Project title	Waterfront Barry	Job number	122374-00
cc	Richard Keogh Jonathan Kinghorn John Smith	File reference	4-70
Prepared by	Roddy Beynon (Cardiff)	Date	5 October 2010
Subject	Response to Audit of Transport Assessment Rev A

This technical note provides a response to the points requiring clarification or comment in the Capita Symonds audit of the Transport Assessment Rev A issued by Arup in relation to the outline planning application.

Figure 1: Queue depletion pattern on Merric Harrier junction link

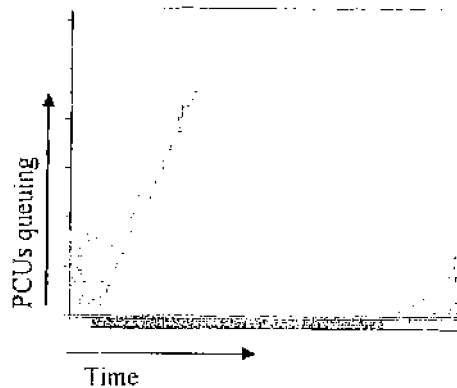
Internal Links, during some scenarios the internal links have a mean max queue (MMQ) above the physical storage but have an end of red queue within storage capacity. As a test queue limiters were applied to the internal links this test forced the mean max queues down and increased the RFC of the feeding arms. In reality when the internal link starts to empty the feeding arm adds to the back of the queue generating a rolling queue that fully depletes before the stage closes down as shown in Figure 1.

Figure 1 shows the back of queue building while the front of the queue is released. The queue becomes fully depleted before the next red stage commences.
